**MASTER PLAN UPDATE**

**SEHOME  
HILL  
ARBORETUM**

**City of Bellingham, Washington  
And  
Western Washington University**

### Sehome Hill Arboretum Master Plan Update

## SIGN SYSTEMS

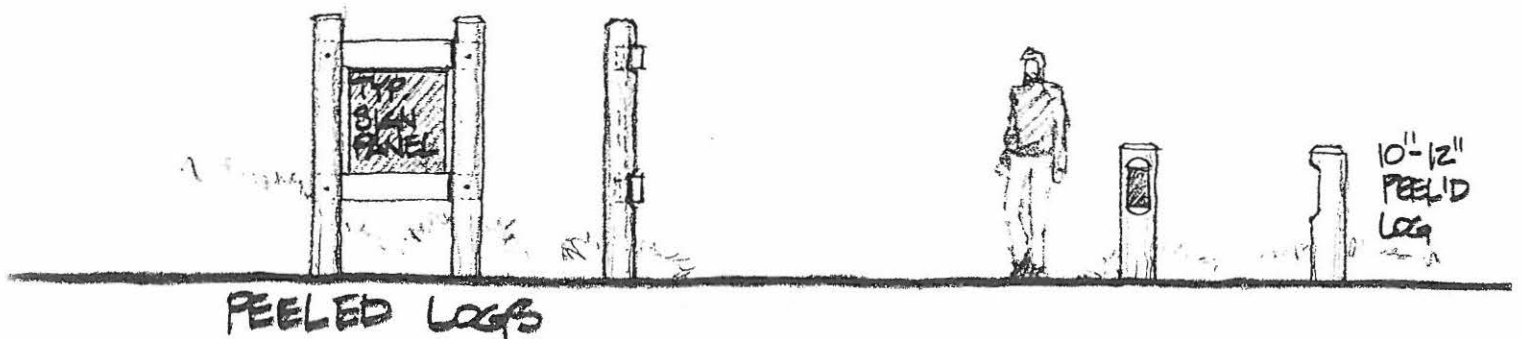
1. Prefer peeled logs for signs. Don't put up too many signs.
2. Peeled logs are in line with the yellow-striped logs that mark trail entrances. Love this new fiberglass material.
3. Please do not use steel signs. The peeled logs are by far the best.
4. I agree steel is ugly and reminds me of giant obtrusive structures. Peeled logs would be good.

5. I don't like the metal signs.

The development of a good way finding, directional and informational signage system should be pursued. Sign system design should have a natural theme appearance with specific elements made from materials both durable and easy to maintain.

**ALTERNATIVE 1**  
**NO CHANGE**  
MASTER PLAN UPDATE - 2002  
**SEHOME HILL**  
**ARBORETUM**  
CITY OF BELLINGHAM,  
WASHINGTON  
JGM LANDSCAPE ARCHITECTS

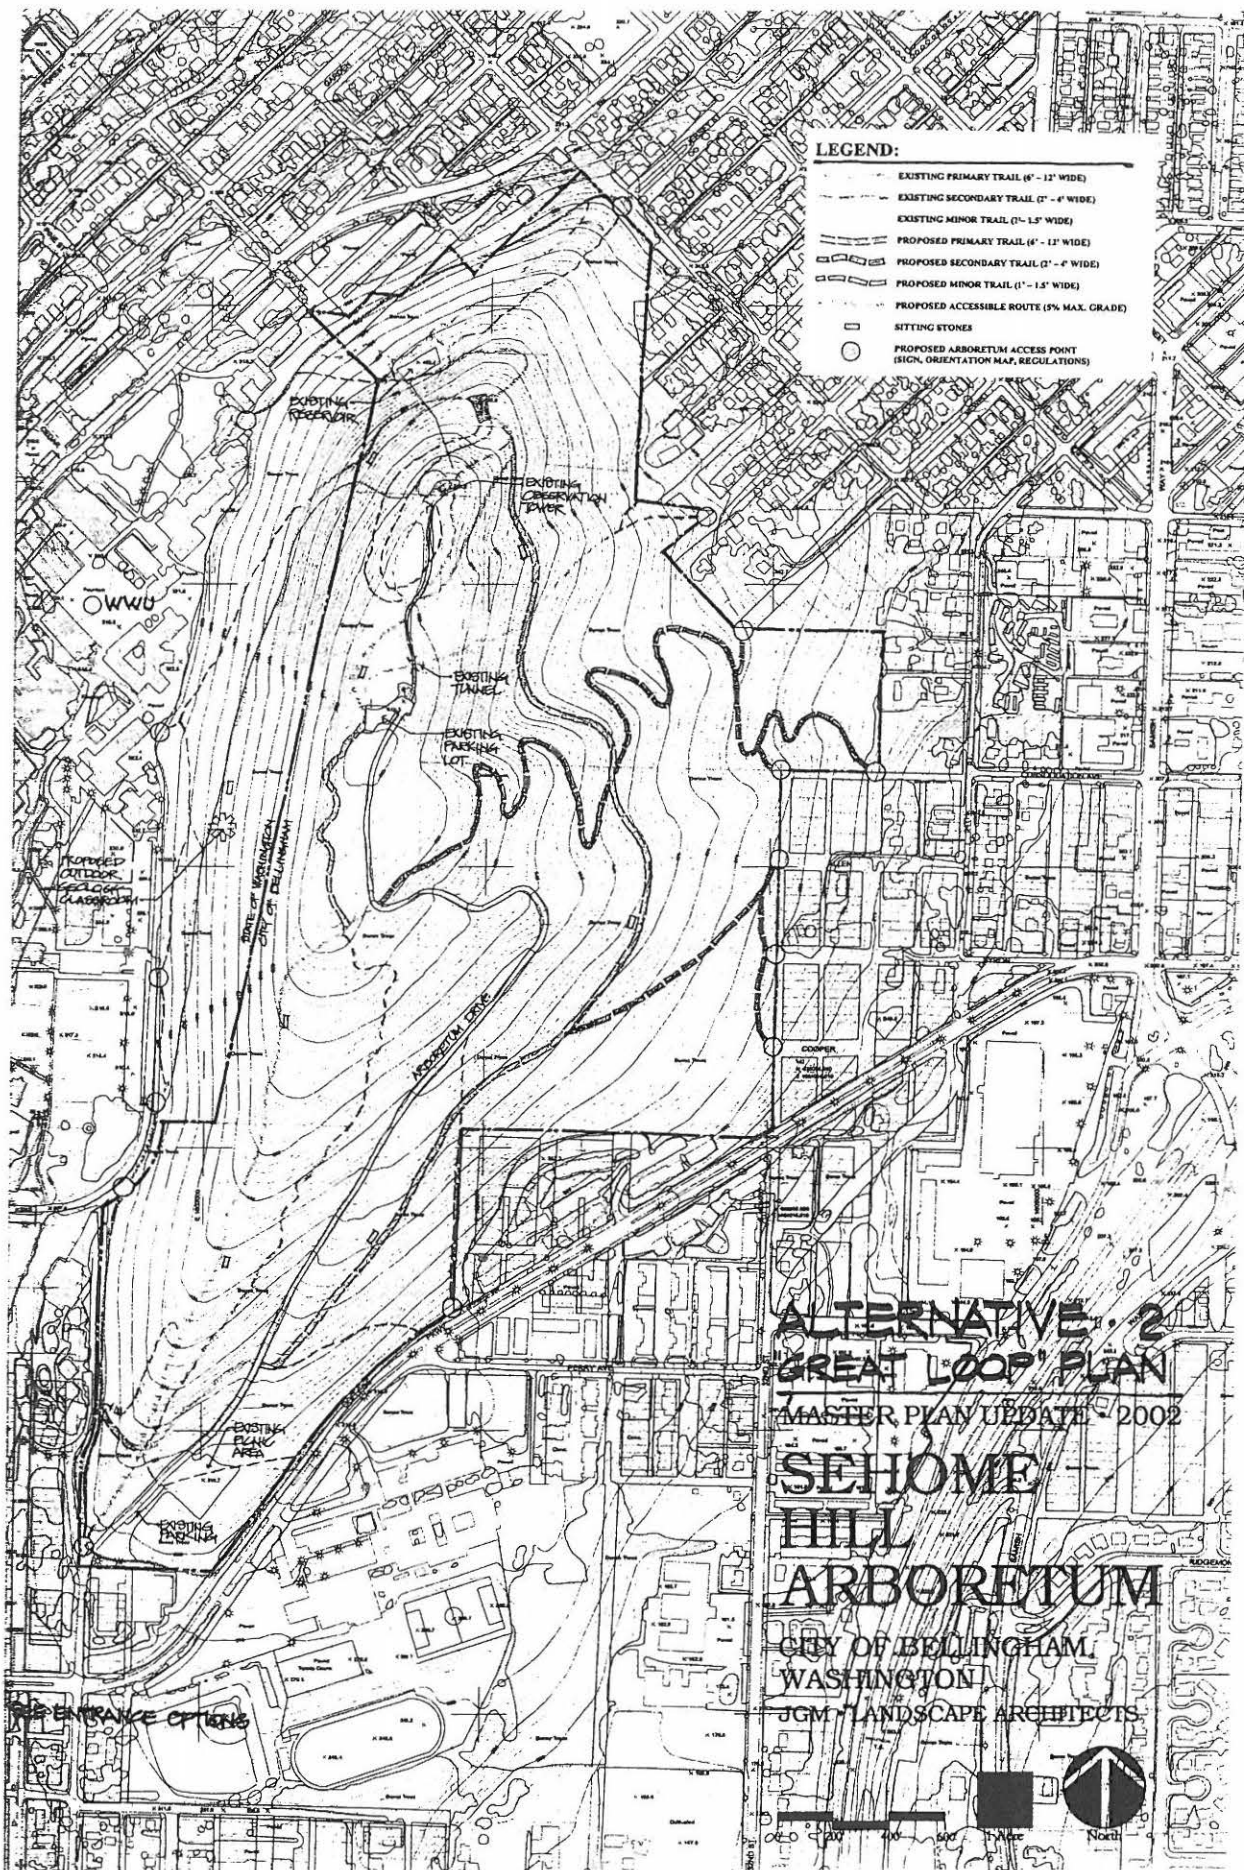
1. To me the word Arboretum suggests as natural a place as possible, with minimal trails and a place to educate ourselves and others about nature. As my daughter grows I hope that natural places remain in Bellingham, with as little construction as possible. The Arboretum, in it’s current state, is one such natural place an my “vote” is that it remain so, which appears to suggest Alternative 1 – No Change. The proposed Primary Trails on Alternative 2 and Alternative 3 (6’-12’) seems very intrusive and not necessary. I think the gentleman’s idea about special permits for the roads that exist for elderly or handicapped makes good sense if accessibility is the reason for redoing the master plan. That would allow elderly and handicapped access to the beauty and wildness of the arboretum with minimal cost (maintain existing road) and minimal intrusion. Marsha Burly.

2. As an avid outdoors person (with my friends) I don’t always want to have to get out of town to experience a serene and natural setting. What makes the Arboretum an Arboretum is that it is in as natural state as possible. There is already a road up to the top and a wheelchair accessible trail. Whenever I go to the Arboretum I encounter others who also enjoy the serenity. It won’t be very serene if more trails/roads are put in. There are plenty of places to go that are well marked and easily accessible. Those people who truly appreciate nature know about the Arboretum. If you add more access the lovely peace will be destroyed, as will some trees and other vegetation. So often improvements

are actually degradations. After all, can one really improve on Nature? Please, respect the Arboretum for the jewel that it is in its current state. Thank you.

3. Additional Signage on B. Mac. Parkway, NO Improvements! Anyone can find the Arboretum; it's the large bunch of trees high above the City!
4. Leave it the same. Monty Thompson.

5. Existing trails on the eastern side would be fine if marked and maintained – more could use them without making them 4' wide. Granted, running into tarp shelters can be scary when alone, and could be remedied by better access.

6. NO CHANGES. This is the only natural area that has been preserved in any way.
7. We think the true uniqueness of the area comes from just that, it is unique. It is not a "sterilized" park. Leave it as wild as possible. Make as few changes possible. Steve and Catherine Carey.

8. NO Paving – NO Manicuring.
9. As a member of the track & XC teams of Sehome as well as a frequent runner of the Sehome Hill Trails, I feel the trail system is best as is in its state that is more natural than 50 years ago. It seems like these trail revision plans would turn the hill into more of an ugly highway system than a park. Also, more trails means more people. I like the park because it's quiet and serene; I don't want everyone and their Uncle on Sehome Hill. Other park revisions I have seen make the park ugly and obviously a triumph of man to build concrete trails. I want Sehome Hill to stay natural. Let it be!

**ALTERNATIVE 2**  
**'GREAT LOOP' PLAN**  
MASTER PLAN UPDATE - 2002  
**SEHOME HILL ARBORETUM**  
CITY OF BELLINGHAM, WASHINGTON  
JGM LANDSCAPE ARCHITECTS

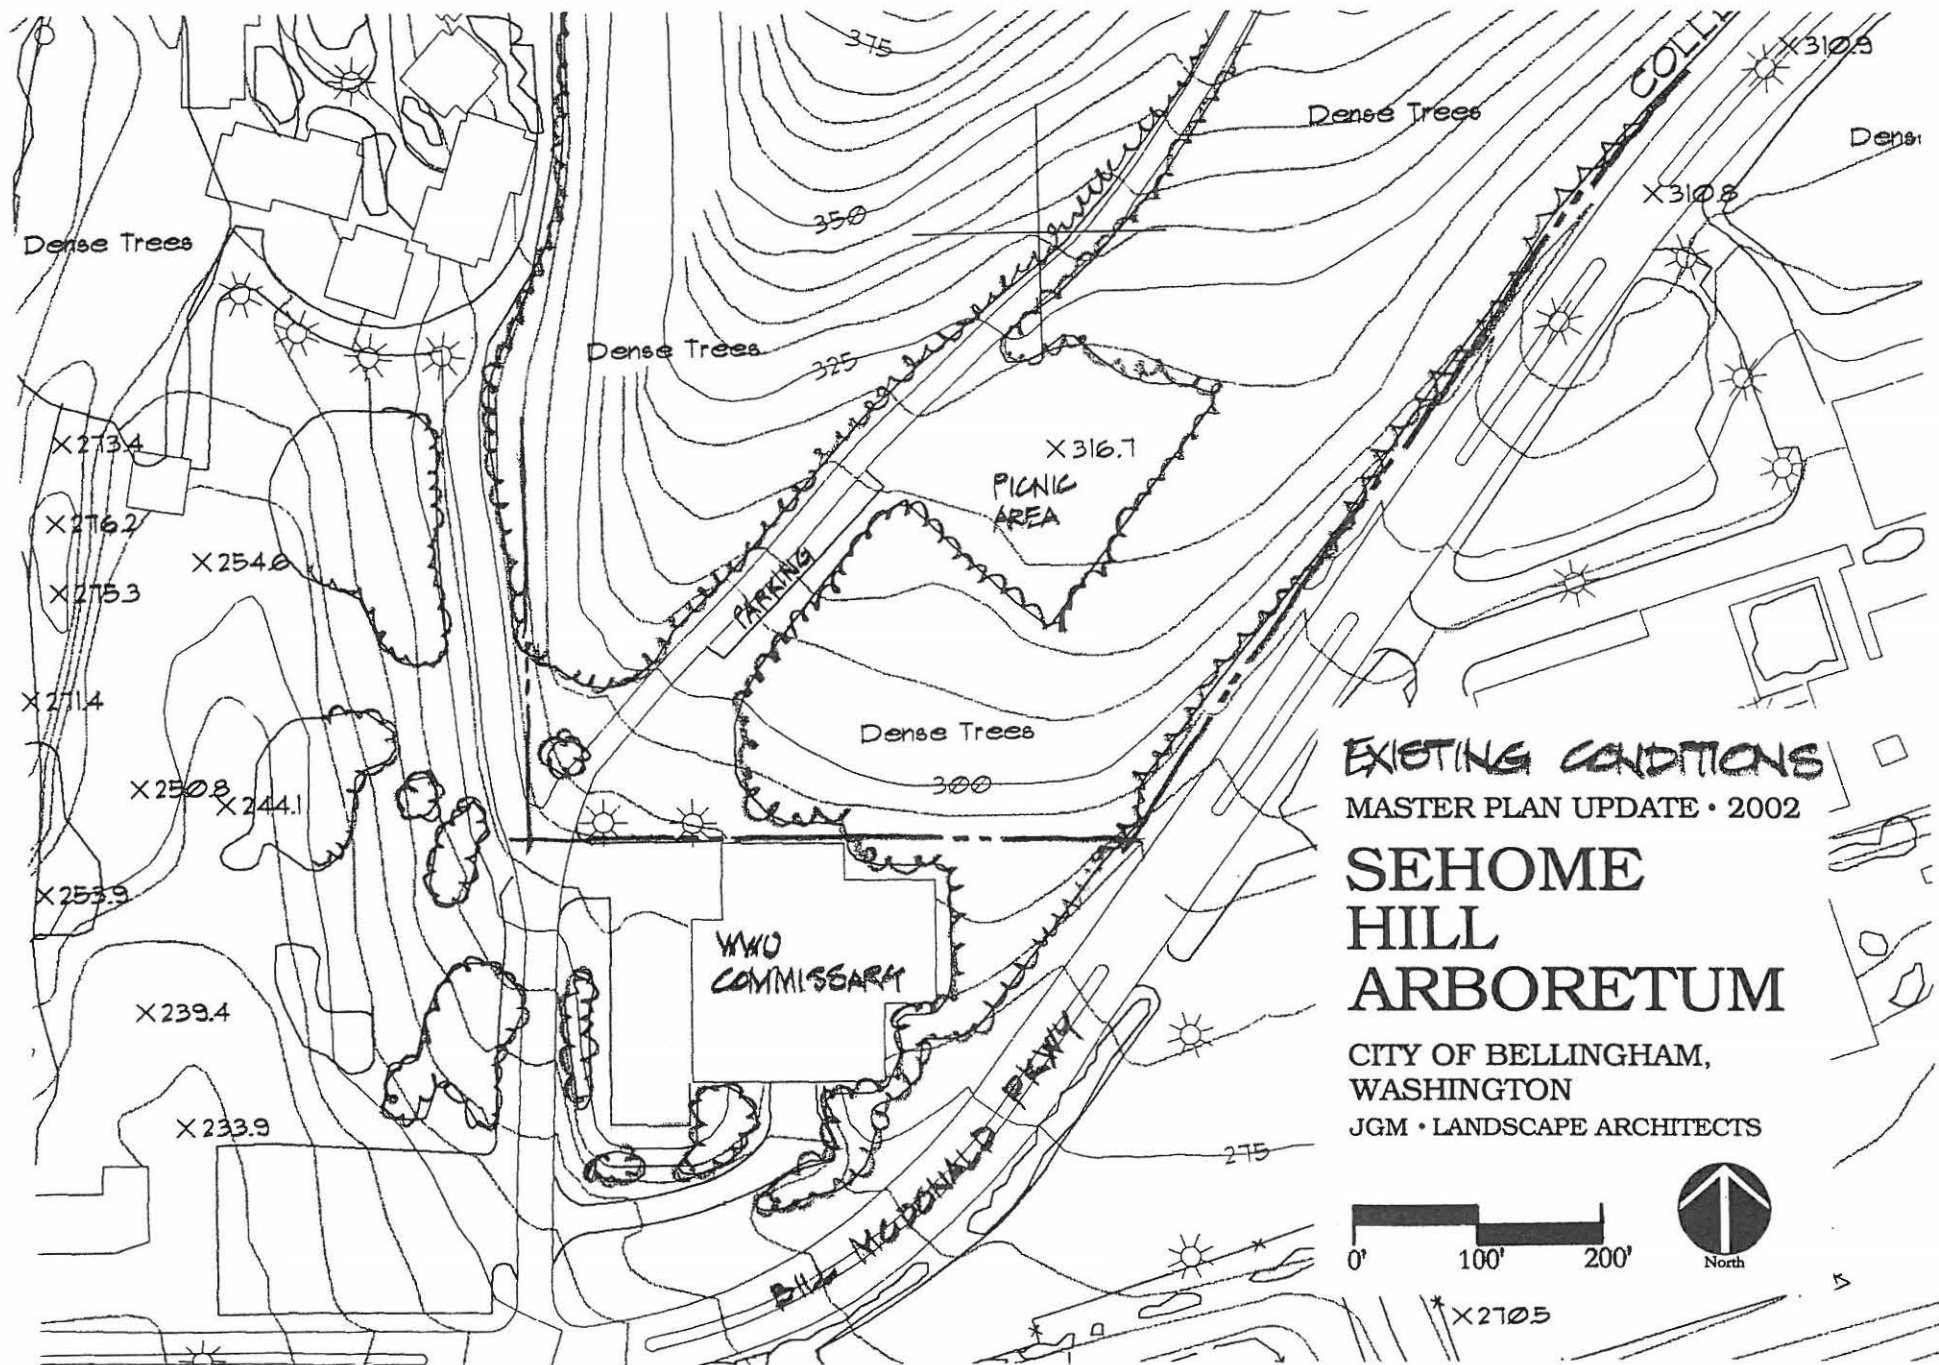
1. I like alternative #2 – nice loop trail. John Hodge.
2. Animal overpass.
3. Ring trail is a great idea when you can afford it. East Side entrances are real important now that the new construction is done.
4. NO more PAVING – NO CLEARING.
5. This is a place for hiking – can't think this trail would be beneficial because it would increase the foot traffic too much.
6. Try to incorporate any changes so that they don't unnecessarily impact the natural character of the Arboretum.
7. Don't make the new trails so wide. Two feet maximum is all that needed for width.
8. I like the concept of loop trail.

## VIEW CLEARING

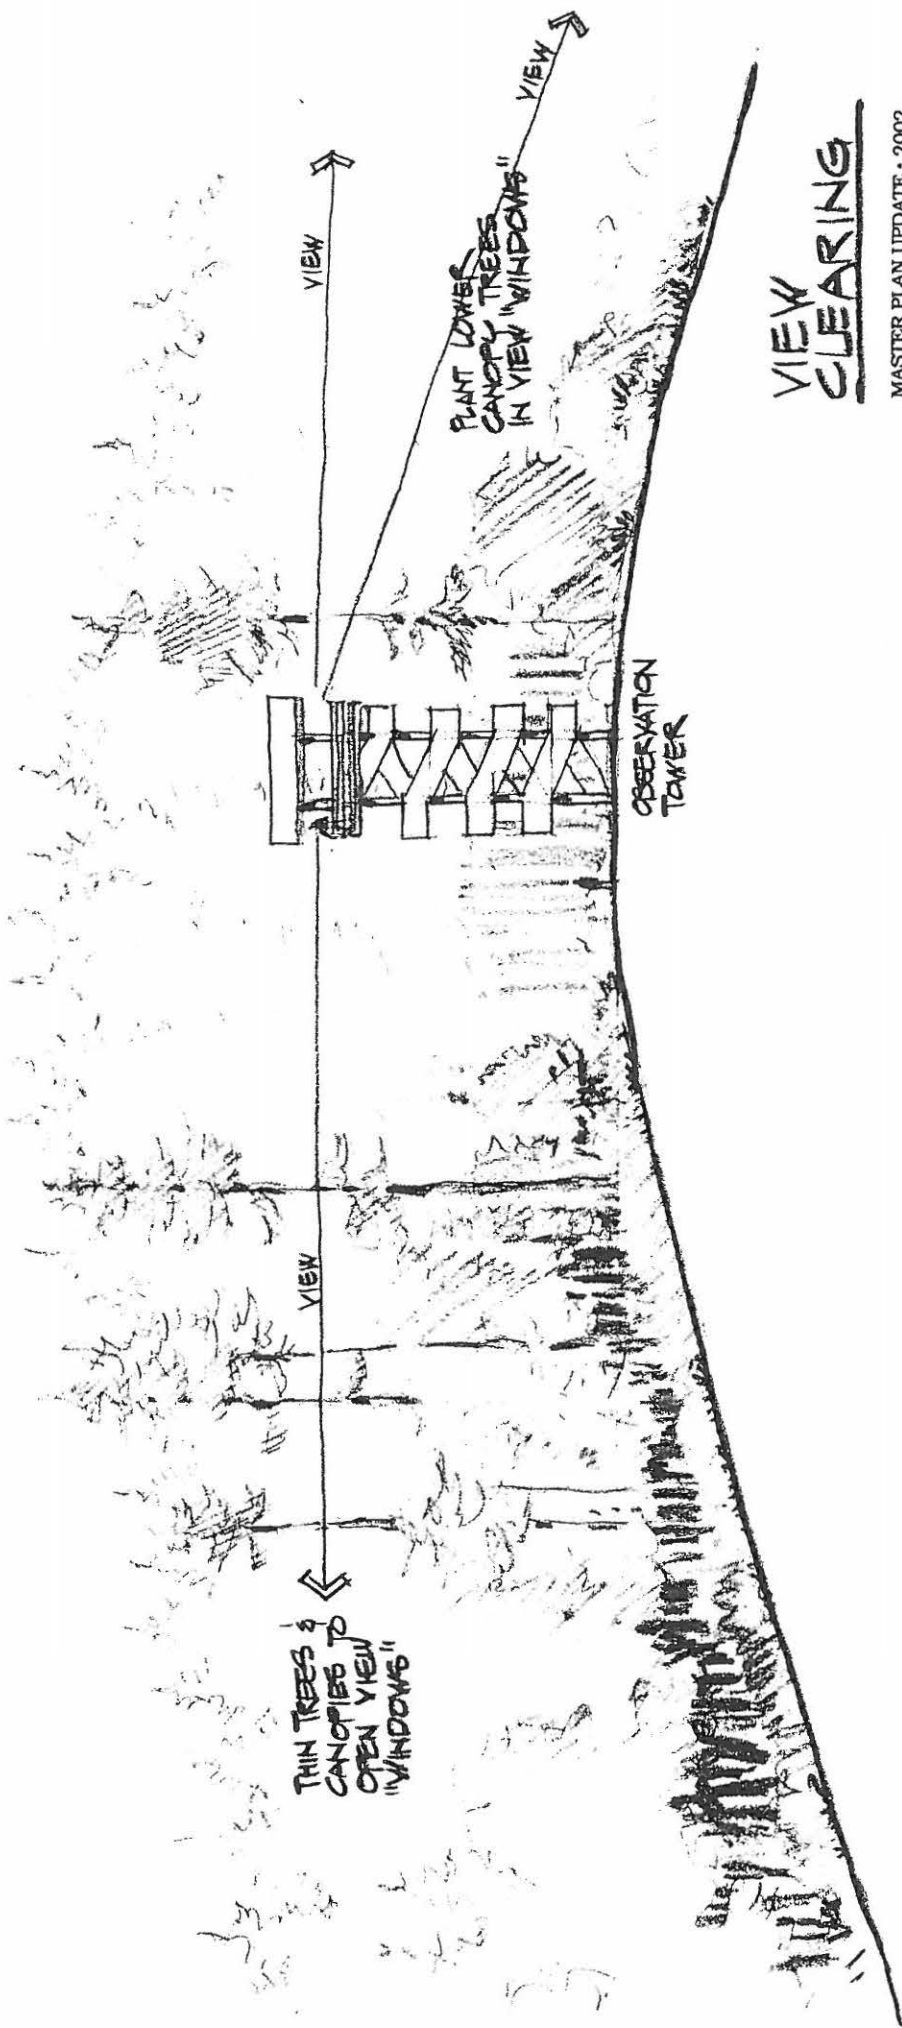
1. In favor of judicious limbing of trees and thinning of trees to improve view from tower.
2. I am perfectly satisfied with the current tower. It seems like it gives a better view than the proposed ramp tower. Improved viewing is good as long as cutting is very selective.

The Board agreed that selective pruning could be done to reopen view windows to Downtown Area/Bellingham Bay, the San Juan Islands, Mt. Baker and the Canadian Cascades.

# VIEW BRIDGE

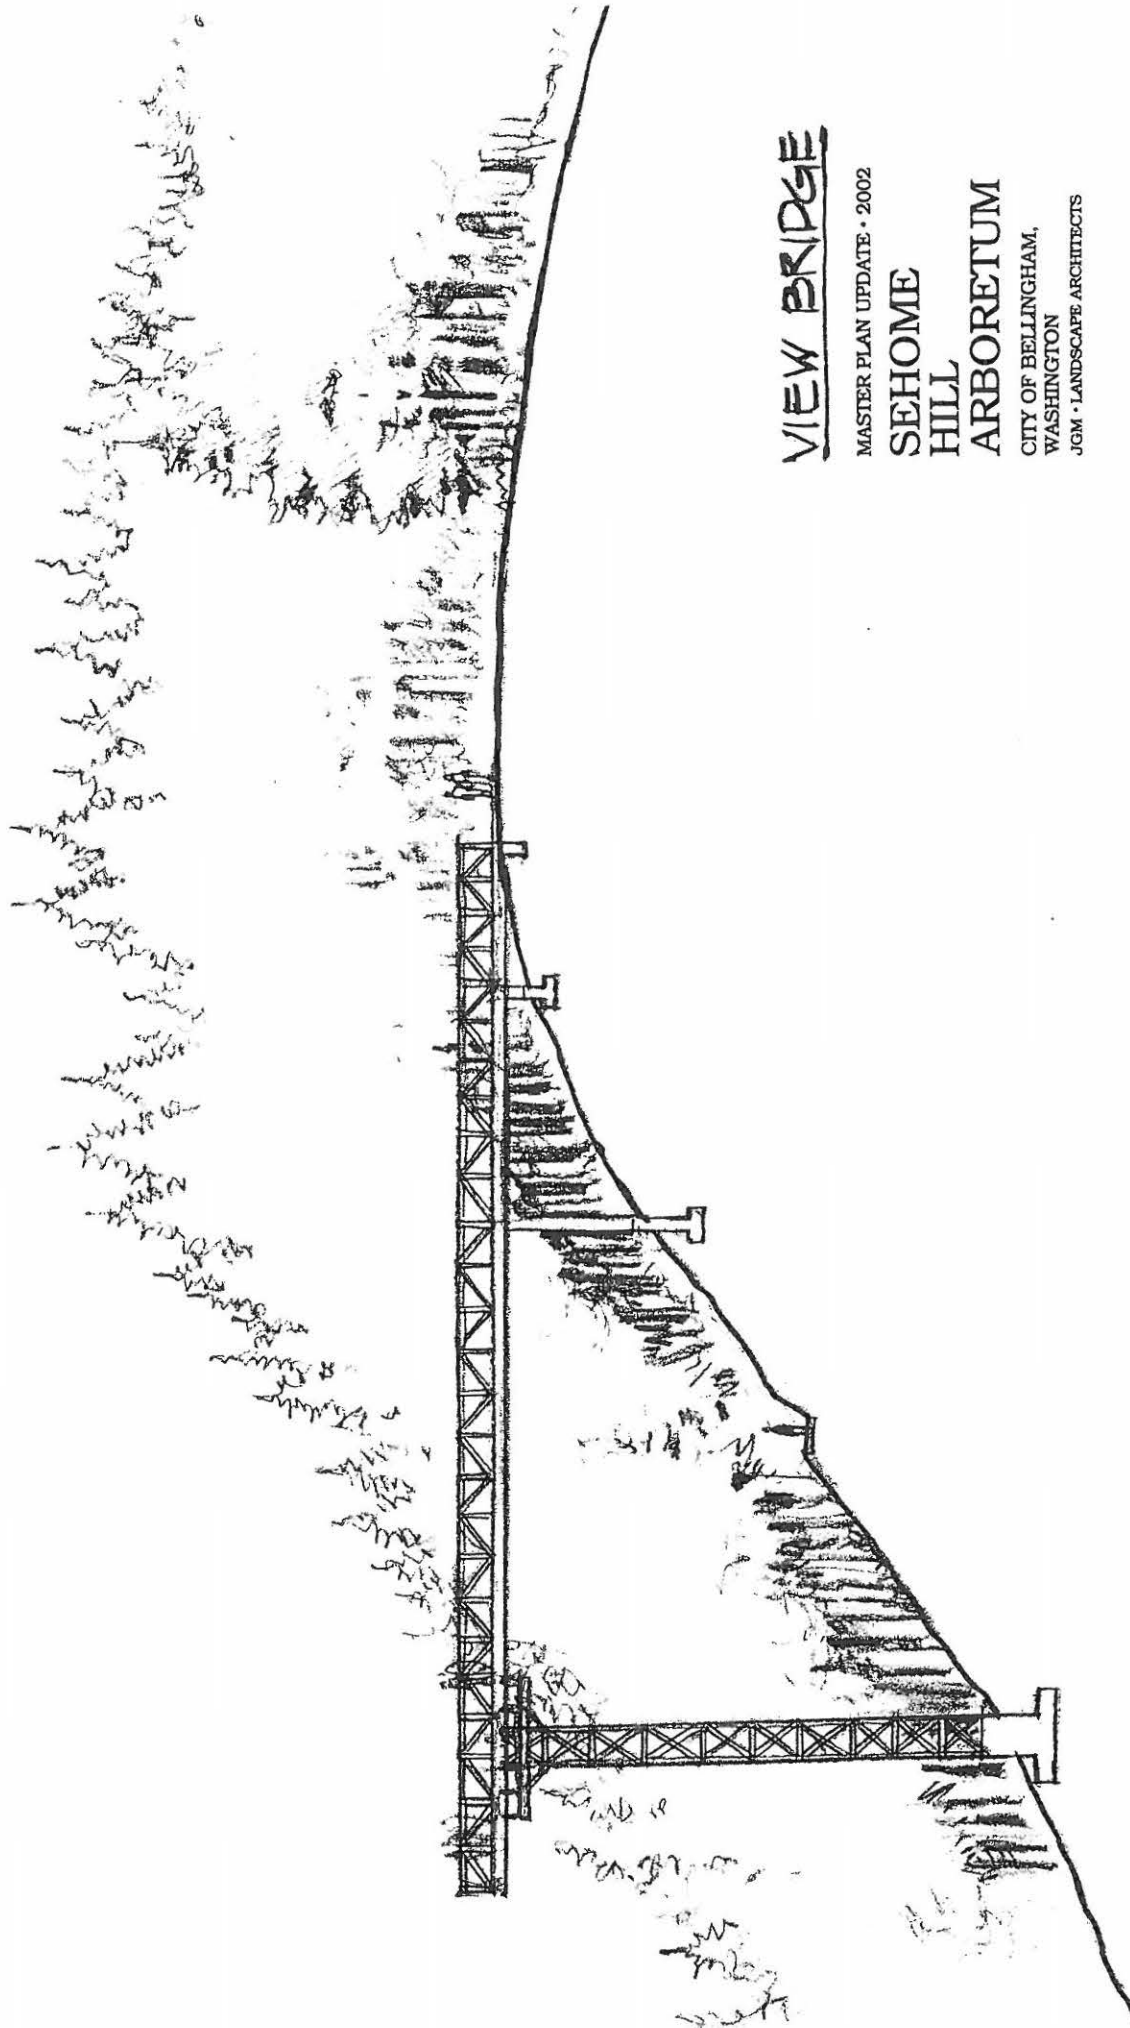
1. This is cool, when can we afford it.
2. Is cost of view bridge justified based on likely use by handicapped visitors? I would doubt it.
3. I think this structure may be too intrusive for such a natural setting. John Hodge.
4. I'm not sure about this. Is it possible to make a wonder structure? Perhaps smaller viewpoints would be better.

The Board agreed that the horizontal tower concept was good, however, public comments were relatively negative. Development of the tower would be expensive and would not be a priority for future funding.
